From: [Teresa.Casey](#)
To: [SIDS](#)
Subject: Planning case 320705 – FuturEnergy Knockshanvo
Date: Wednesday 5 August 2026 14:18:38
Attachments: [Teresa OConnell response to Knockshanvo Response F reports July 2026.doc](#)

Re: Planning case PA03.320705 – FuturEnergy Knockshanvo Designated Activity Company

I would like to bring the following observations to the Boards attention in relation to the responses received for the proposed Knockshanvo Windfarm planning application:

Figure 1: Minimum rotor-blade-height comparison. The 29 m / 20 m comparison is used only to explain the 362.5 m sensitivity test. It does not establish a biological threshold.

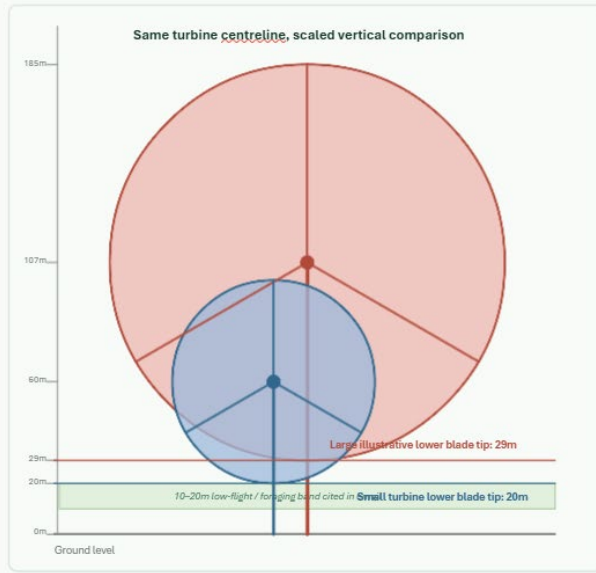
The displacement approach adopted within the assessment relies upon evidence derived from a study context involving turbines that are materially smaller than those proposed at Knockshanvo. The assessment nevertheless applies a 250 m complete-displacement assumption without transparently demonstrating how differences in turbine scale have been accounted for within the habitat-loss calculation.

The Pearce-Higgins study records an implied/weighted average rotor diameter of approximately 47.2 m, a weighted average hub height of approximately 48.7 m and a weighted average blade-tip height of approximately 72.3 m for the historic study context. The proposed Knockshanvo turbine dimensions are approximately 102.5 m to 110.5 m hub height, 179.5 m to 185 m blade-tip height and 149 m to 163 m rotor diameter.

These comparisons demonstrate a substantial difference in scale between the turbines forming the basis of the cited evidence and those proposed within the development. The assessment does not transparently demonstrate how those differences in hub height, blade-tip height, rotor diameter and swept area have been evaluated in the application of displacement assumptions.

The habitat-loss conclusions therefore rely upon displacement assumptions derived from a materially different turbine context, while the evidential basis linking those assumptions to the dimensions of the proposed Knockshanvo turbines is not clearly apparent from the material presented. As a consequence, the relationship between turbine scale and the adopted 250 m complete-displacement assumption is not transparently demonstrated within the assessment.

Figure 3: Illustrative displacement-buffer sensitivity. The 362.5 m distance is not advanced as an ecological threshold. It illustrates the materiality of the Applicant’s selected 250 m assumption because buffer area increases with the square of radius.

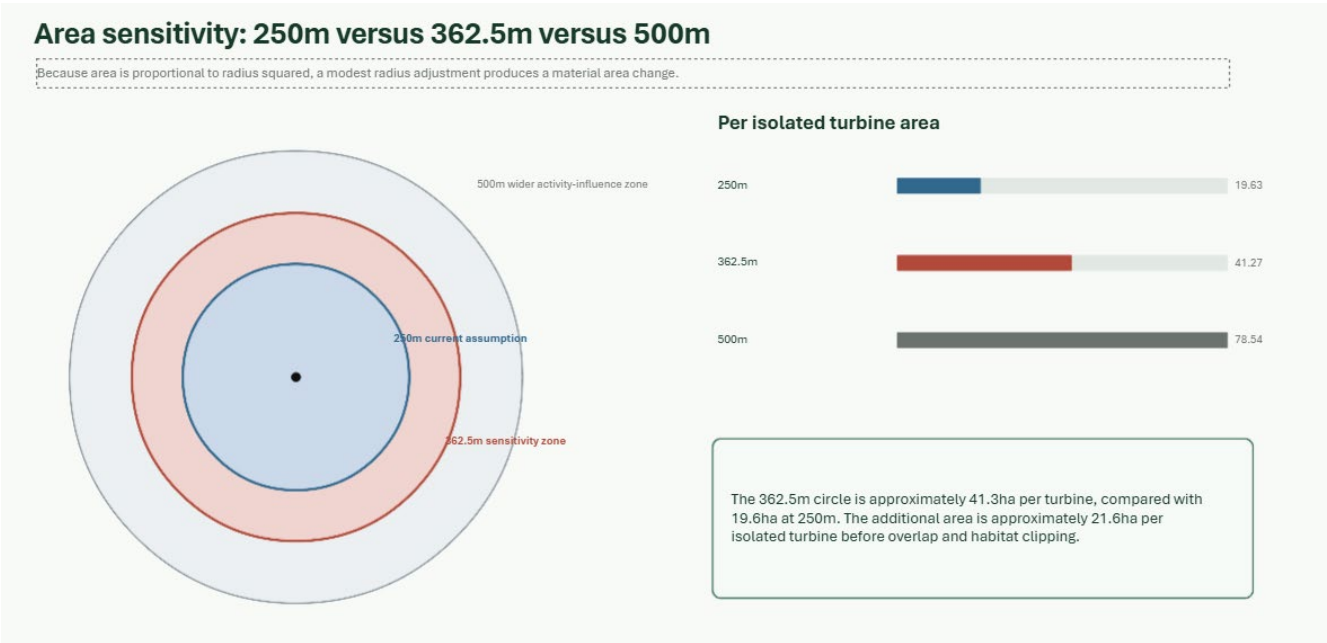
The Applicant’s response records that a 500 m distance was used in a cumulative GIS exercise because Pearce-Higgins et al. identified significant avoidance between 250 m and 500 m. The response also states that, in the specific case of Hen Harrier, a 500 m radius is considered highly conservative because Hen Harrier have the potential to experience significant avoidance to a distance of 250 m.

The assessment further does not demonstrate how habitat occurring within the acknowledged 250 m to 500 m avoidance zone contributes to the final habitat-loss figures. As a consequence, the relationship between the cited avoidance evidence, the adopted displacement assumptions and the resulting habitat-loss conclusions is not clearly apparent from the assessment.

The habitat-loss conclusions are therefore dependent upon assumptions regarding complete displacement, reduced habitat use and functional habitat availability, while the evidential pathway linking those assumptions to the final habitat-loss figures is not transparently demonstrated within the material presented.

Figure 4: Sensitivity testing implication on cumulative basis

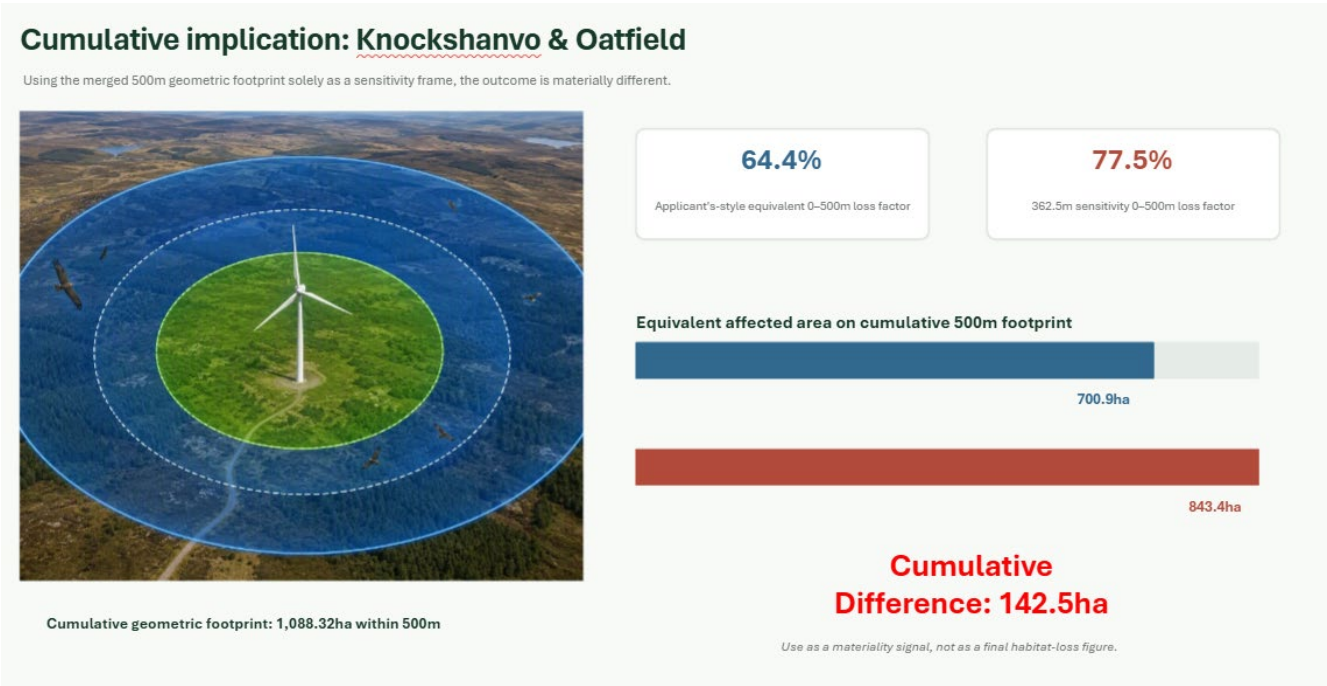
Across the nine proposed Knockshanvo turbines, the equivalent weighted habitat-loss calculation increases from 455.04 ha under the 250 m scenario to 547.58 ha under the 362.5 m sensitivity scenario, a difference of approximately 92.54 ha prior to overlap removal and habitat clipping.

The cumulative sensitivity assessment for the combined Knockshanvo and Oatfield developments identifies a difference of approximately 142.5 ha between the Applicant's displacement assumptions and the 362.5 m sensitivity scenario. These results demonstrate the extent to which habitat-loss outcomes are influenced by the displacement assumptions adopted within the assessment and illustrate the material effect that alternative, but plausible, displacement assumptions have on the calculation of functional habitat loss.

Figure 5: Geometric area effect of alternative buffer radii. This illustration is not a final habitat-loss calculation. Final calculation requires clipping to suitable Hen Harrier habitat, overlap removal, forestry-stage treatment and cumulative Knockshanvo/Oatfield assessment.

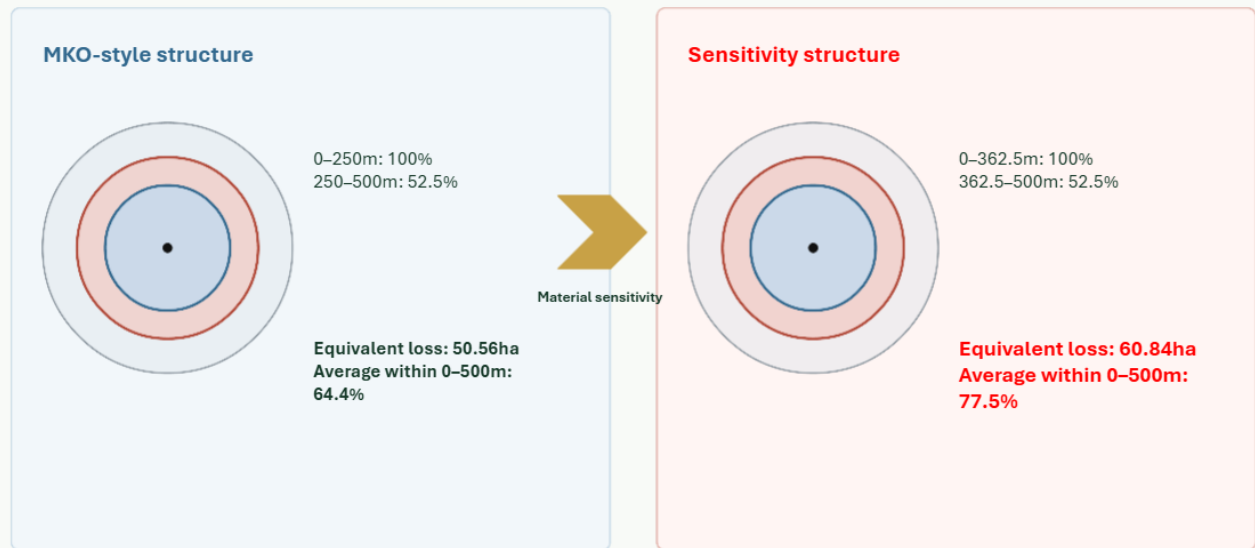
The test keeps the wider 500m framework as presented by Pearse-Higgins but moves the complete-displacement zone from 250m to 362.5m.
